Project T10/1760-D

Revision 14
28 January 2008

Information technology - Serial Attached SCSI - 2 (SAS-2)

Summary of Comments on Serial Attached SCSI - 2 (SAS-2) Standard

Figure 10 — SAS Domain class diagram

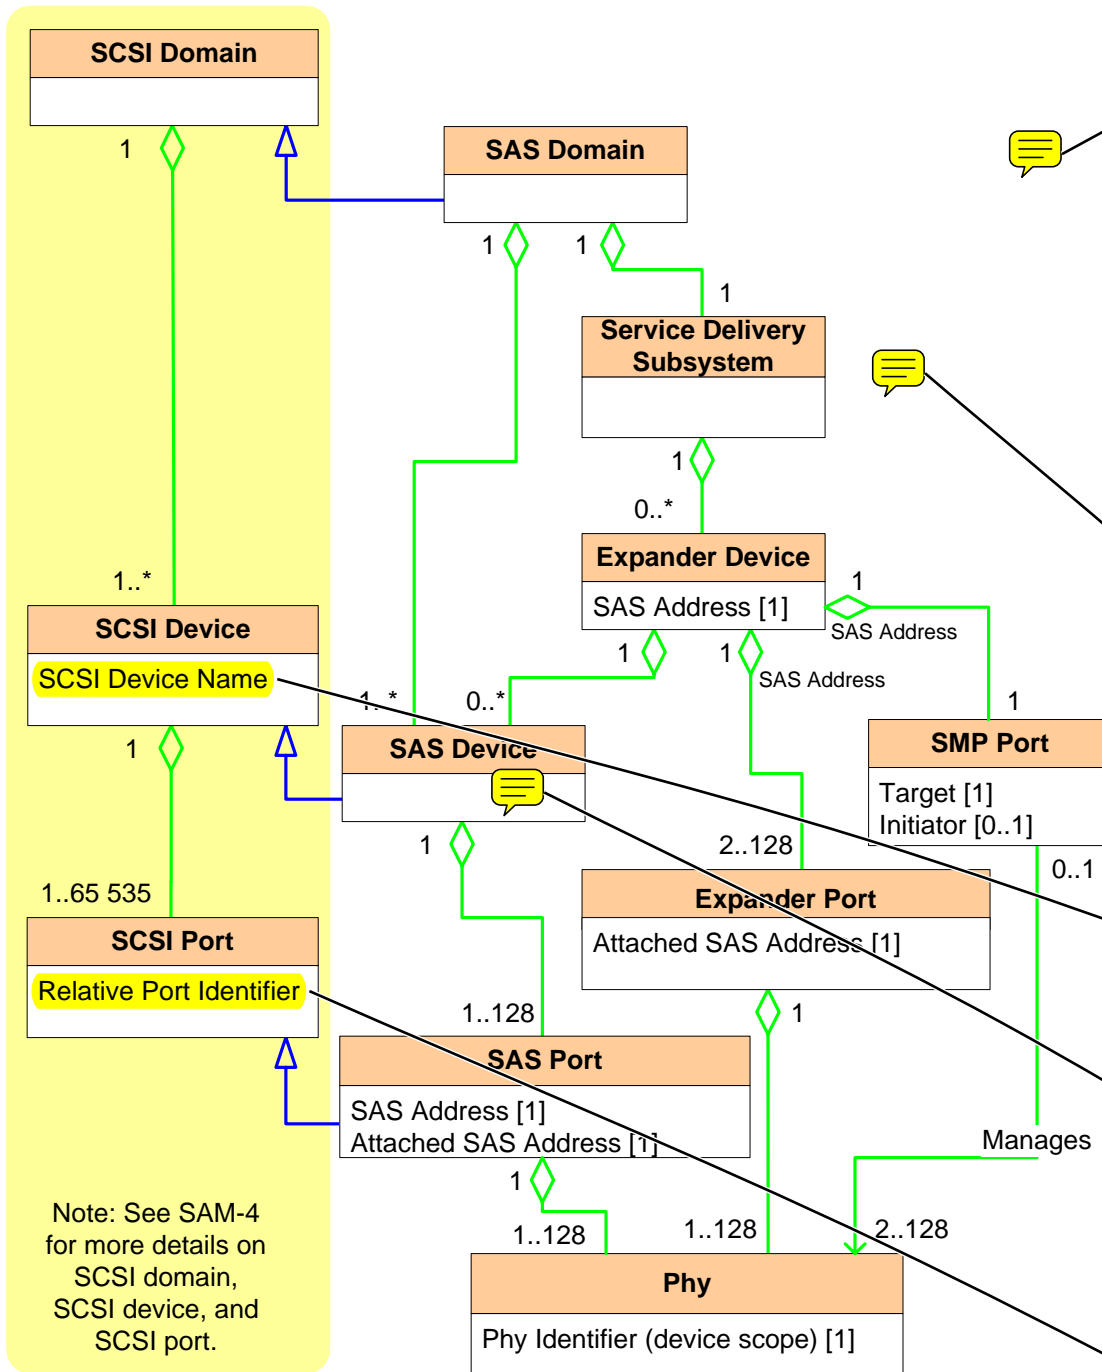
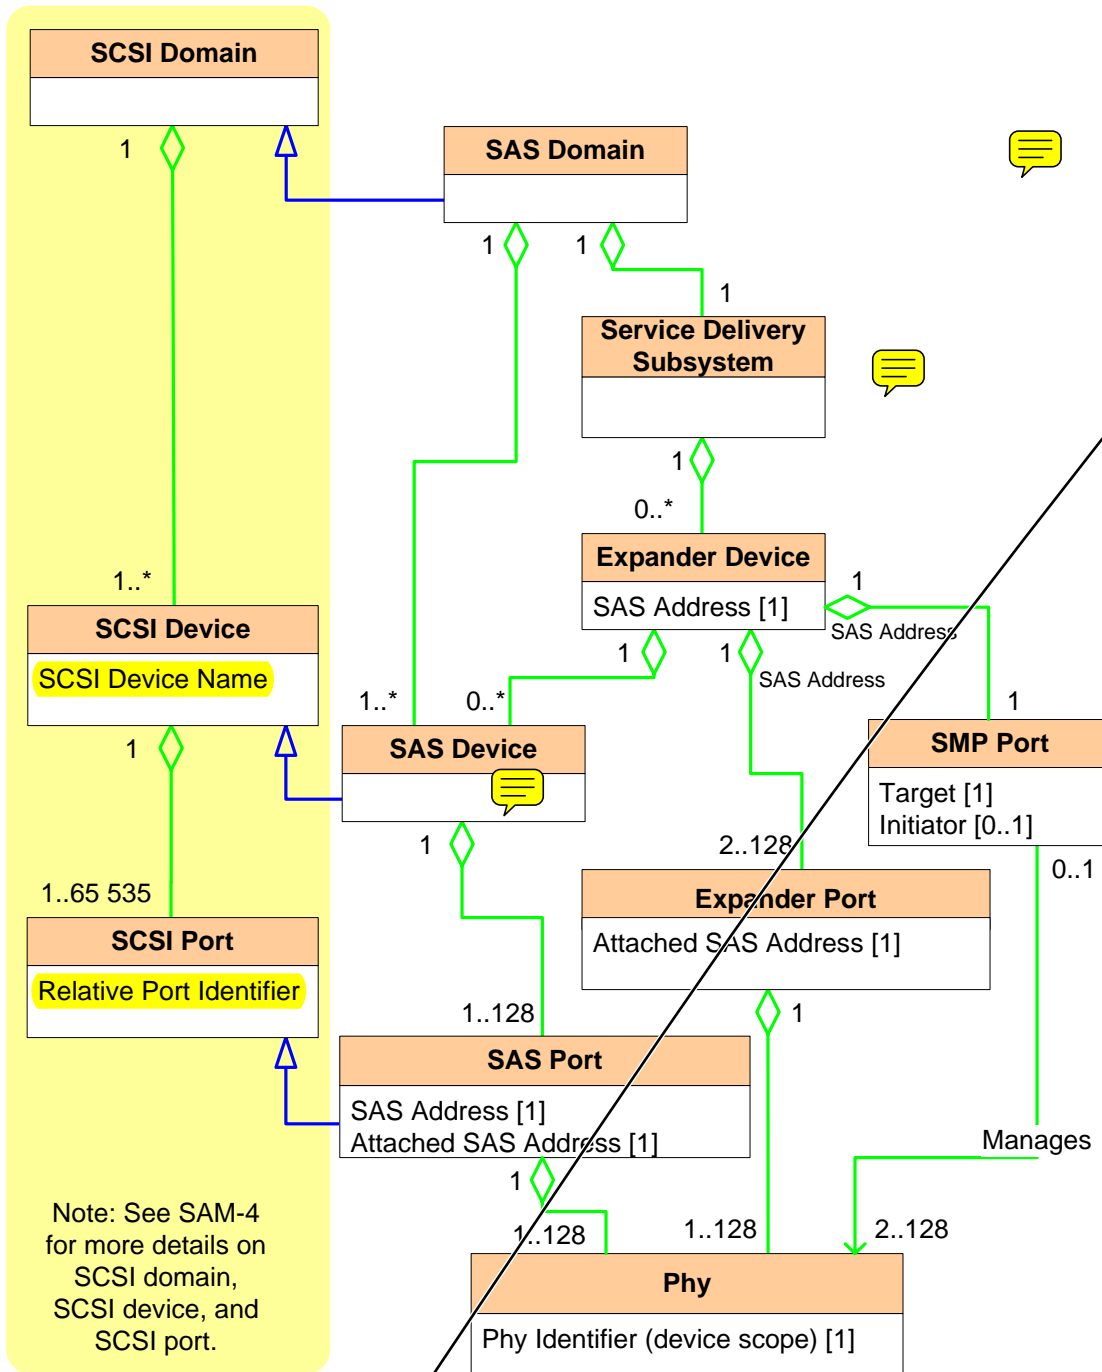
figure 10: changed 1..128 to 1..255

figure 10: changed 2.. to 2..255

Figure 16 — Port class diagram

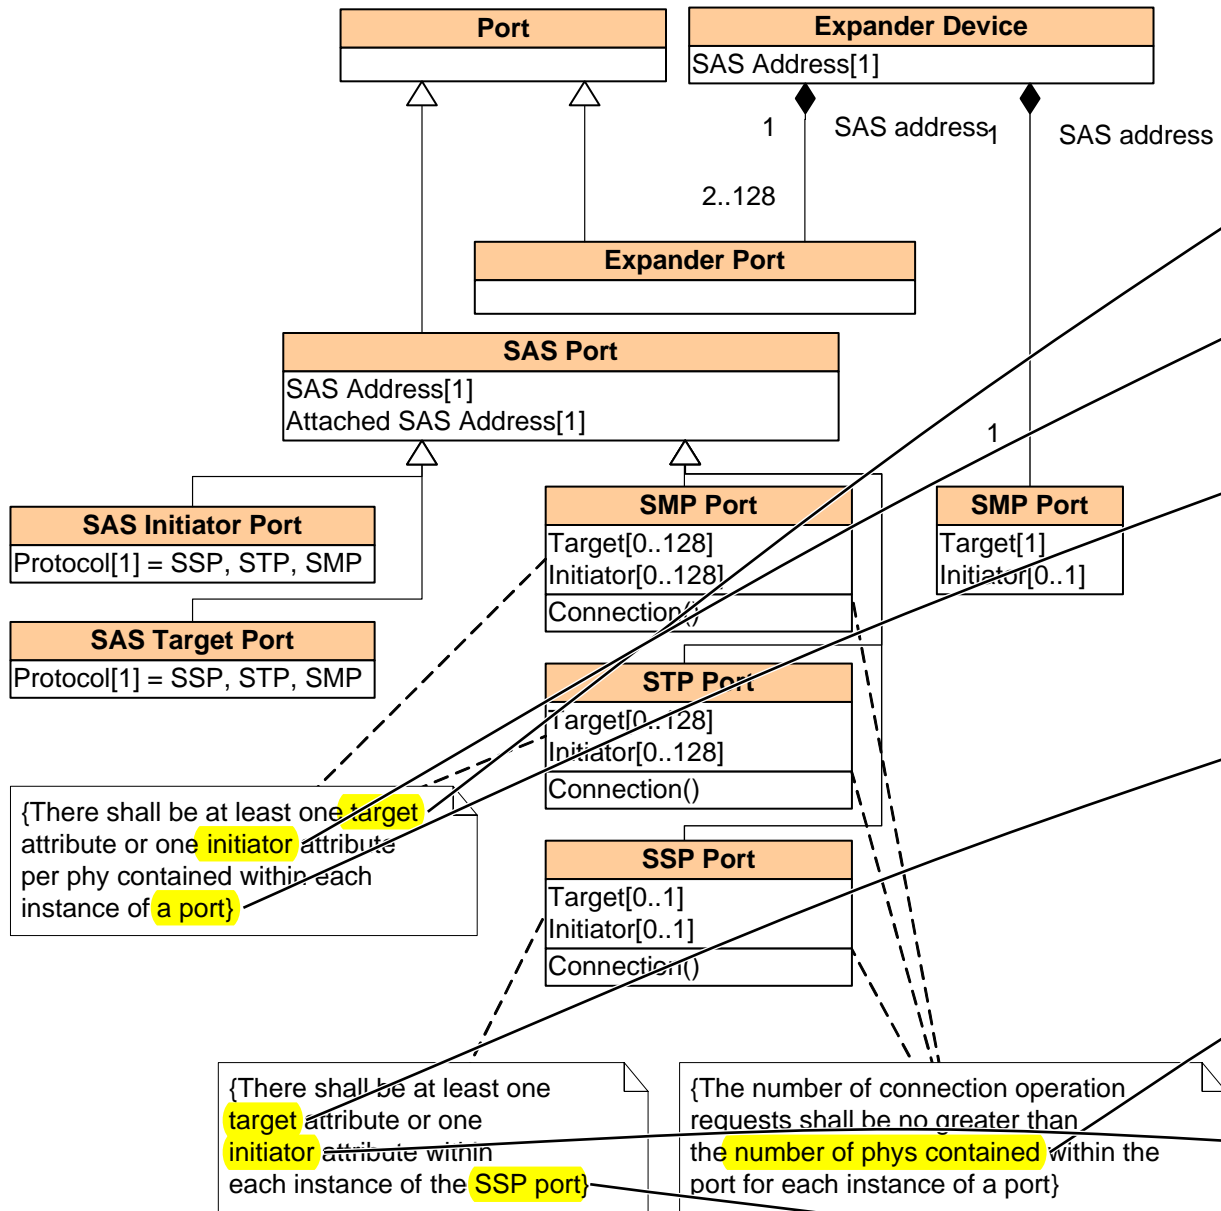
figure 16: changed [0..128] to [0..255] (zero to 255 possible phys)

figure 16: changed 2..128 to 2..255

T Should be << detail is not shown. However, each port

Figure 28 — Multiple connections on wide ports

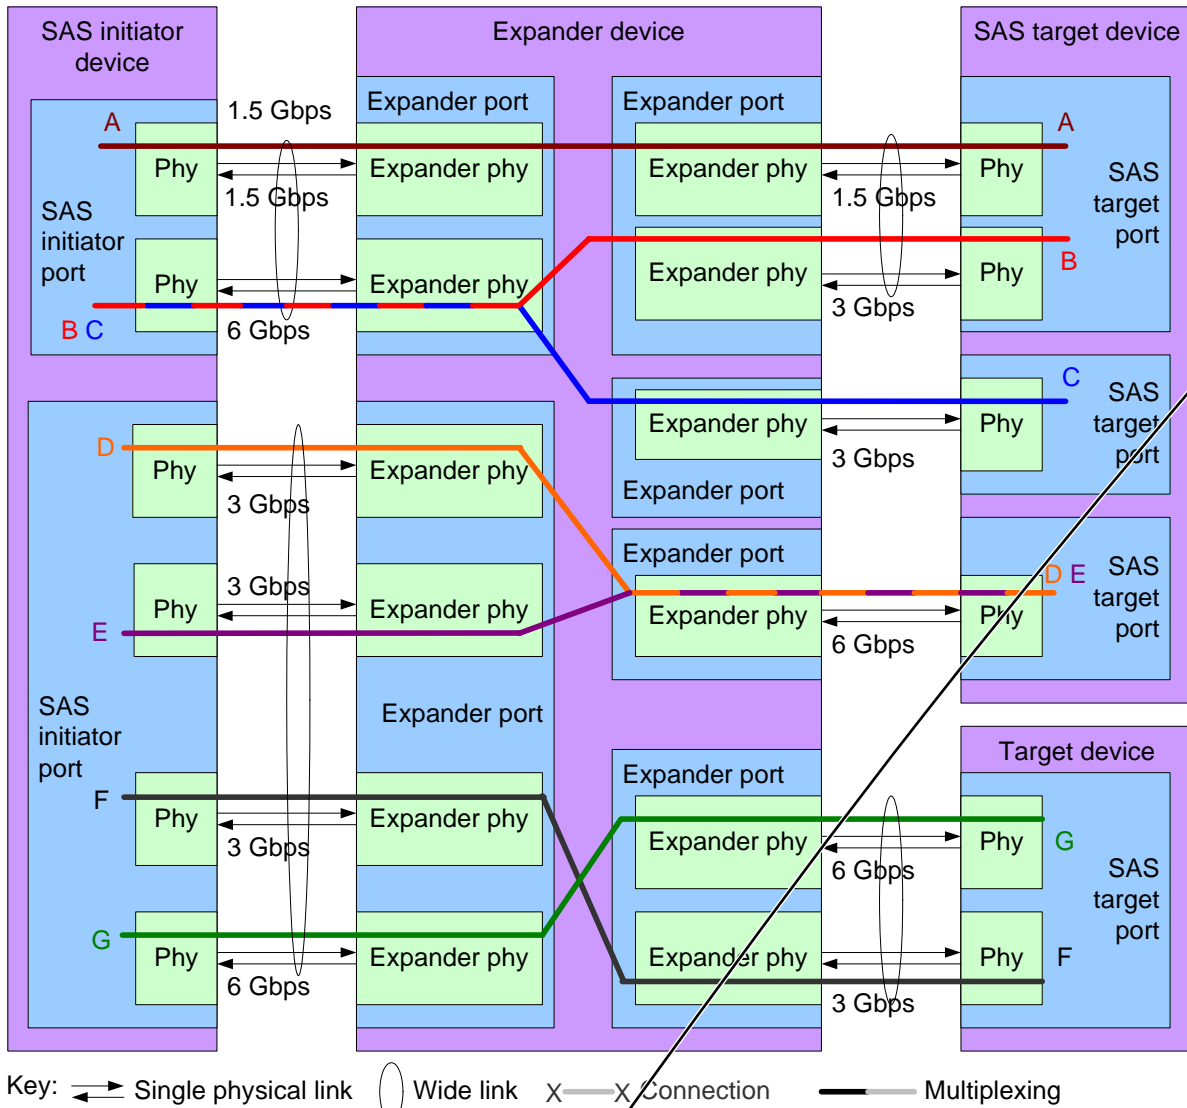
● Author: stx-ghoulder
Subject: Highlight
Date: 4/18/2008 7:19:22 PM
T ACCEPT - DONE (A, B, and C all originate from one initiator port, so should all be listed)

Figure 38 — State machines and SAS Device classes

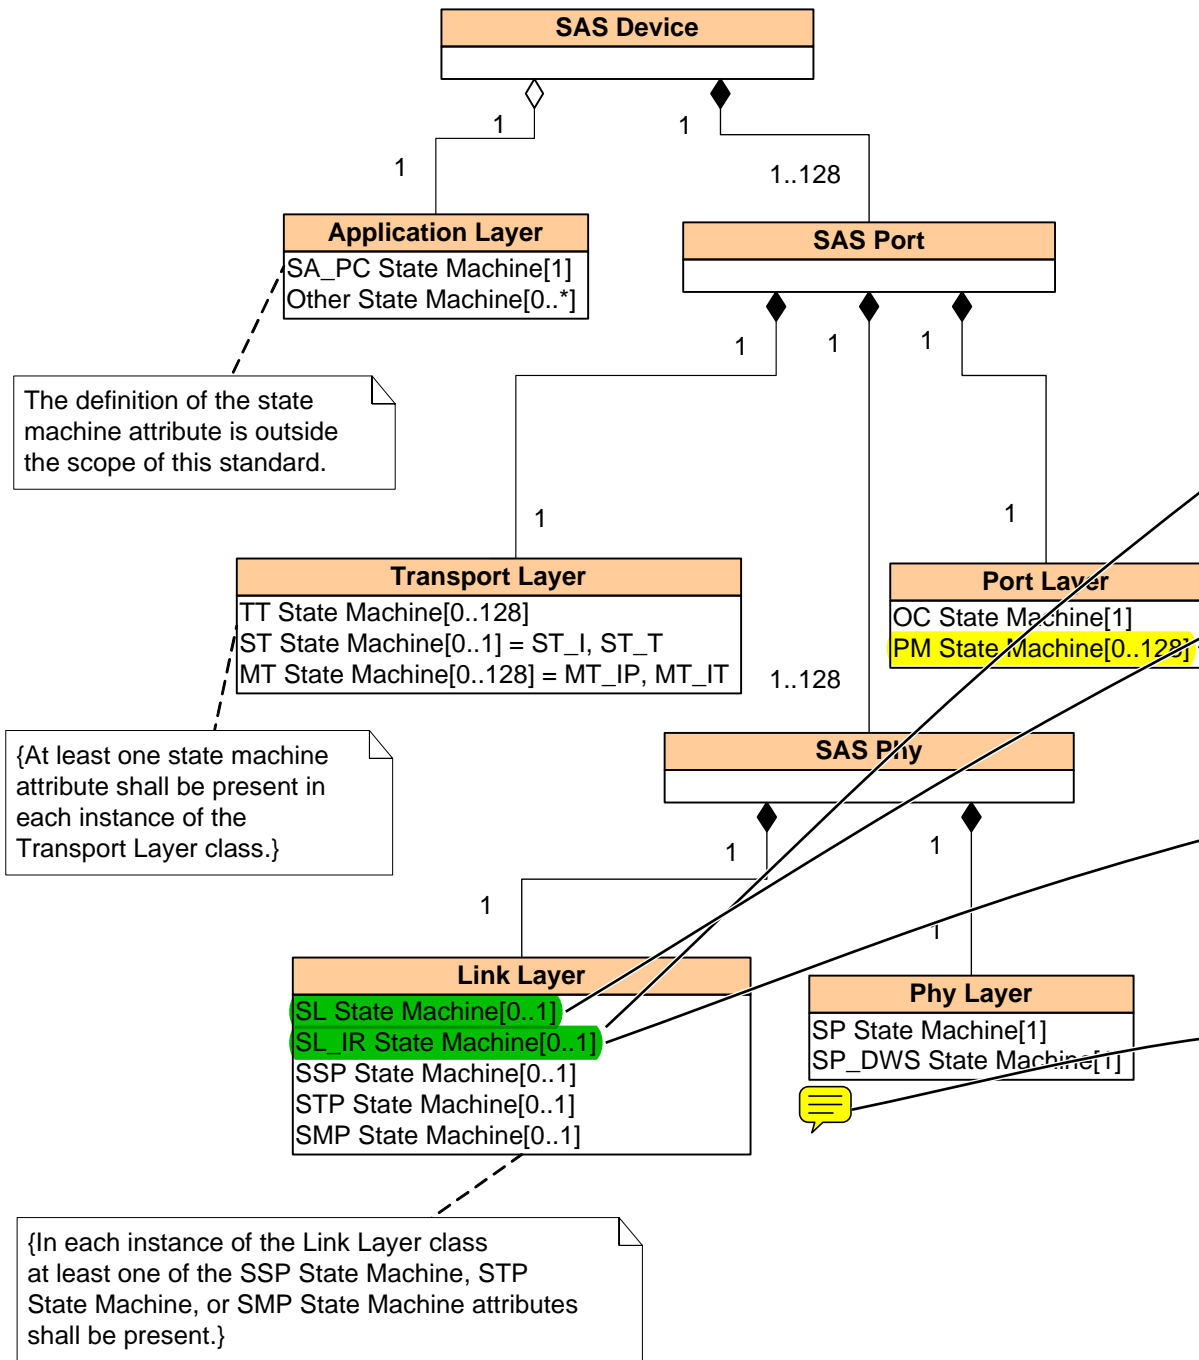
also figure 38: 0..128 to 0..255

also figure 38: 1..128 to 1..255

Figure 40 — Reset terminology

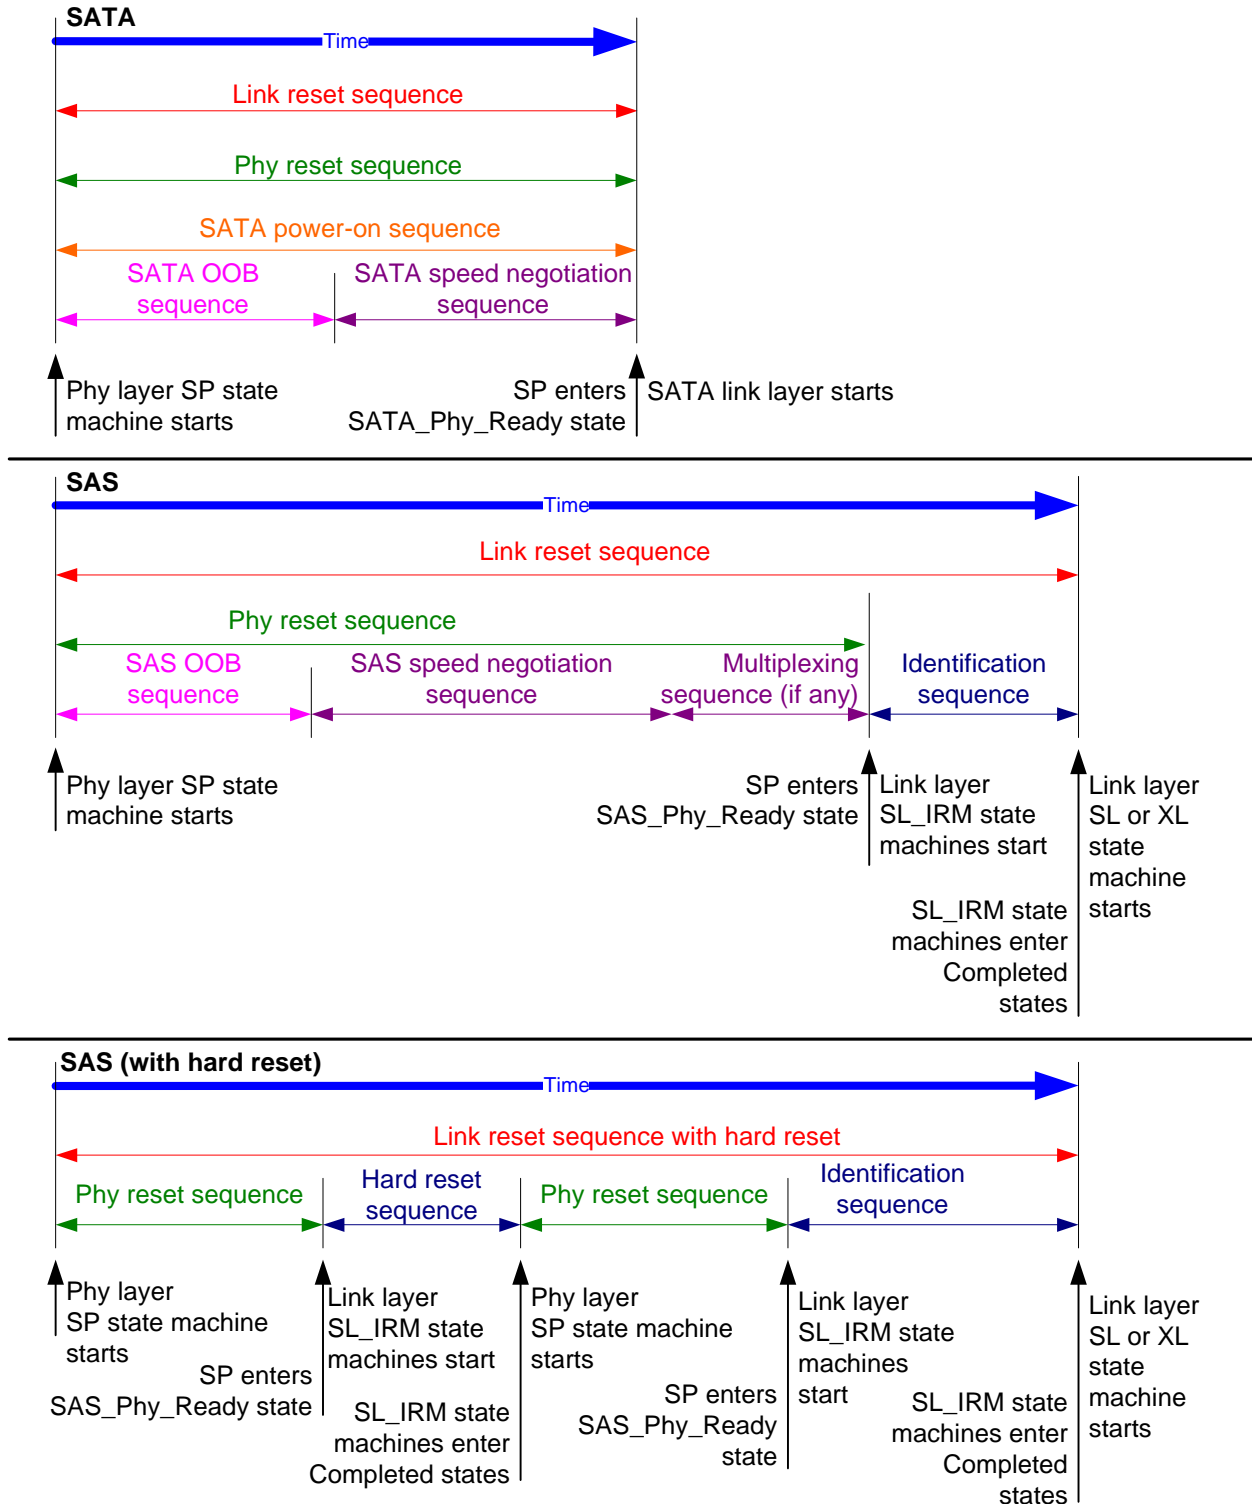
● Author: hpq-relliott
Subject: Note
Date: 3/28/2008 10:05:40 AM
 This figure does not show an SMP phy and associated link layer state machines below the SMP Port since figure 16 does not do so. If the expander allows more than one connection at a time to its SMP target port, then it's effectively a wide SMP port and has multiple phys and link layers. If it only allows one at a time, then it's effectively a narrow SMP port and only has one phy and link layer.

Figure 50 — Expander route index order example

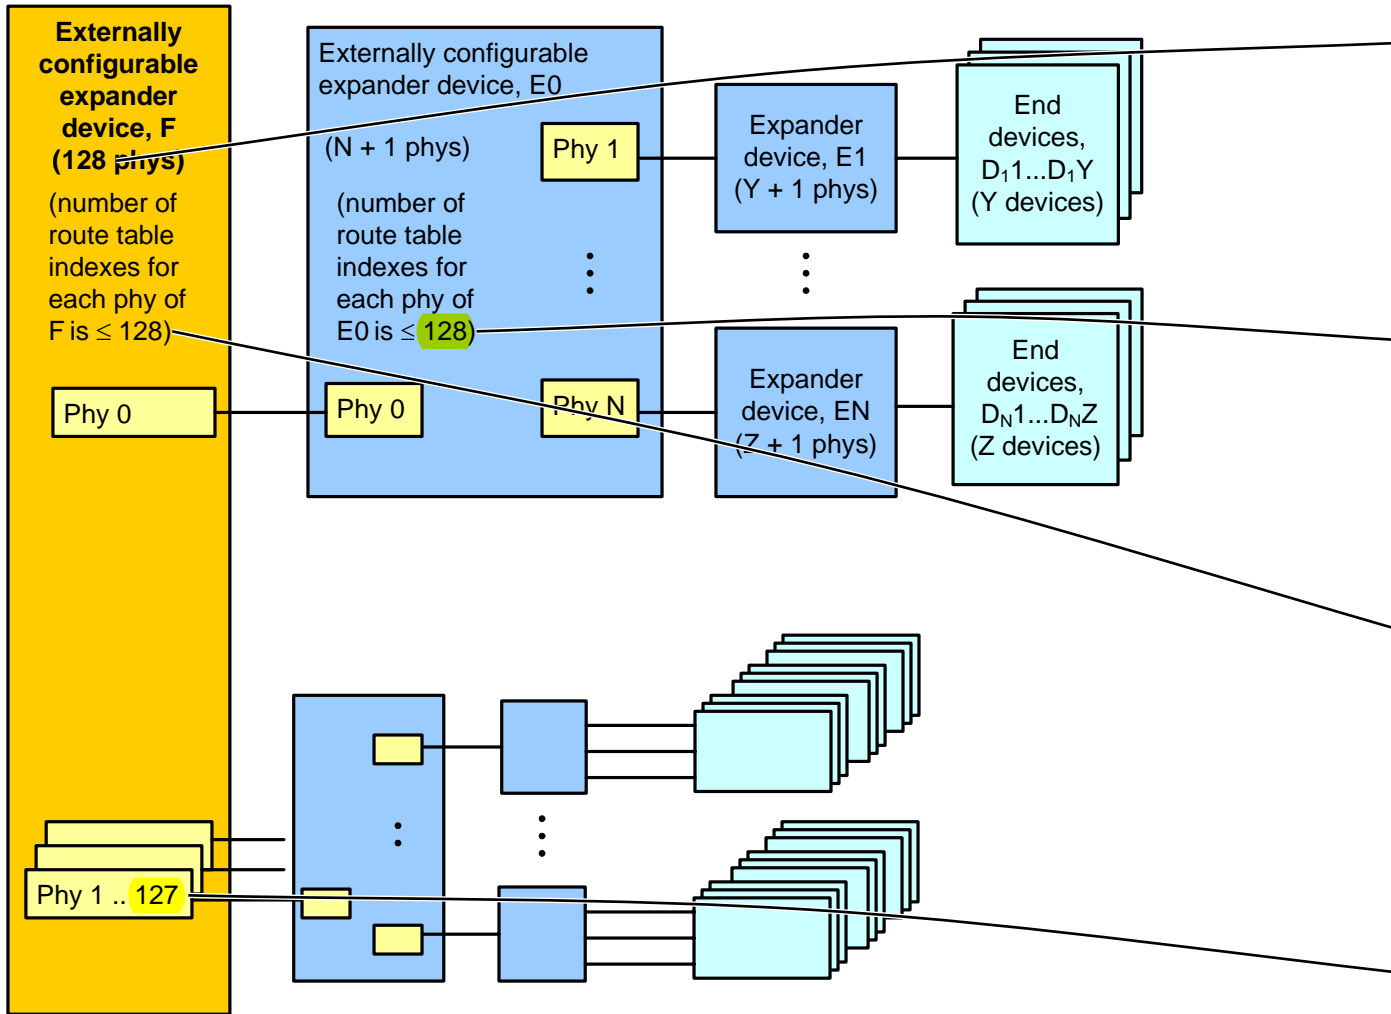
in figure 50, not table 50: 128 to 255, deleted two unnecessary sentences
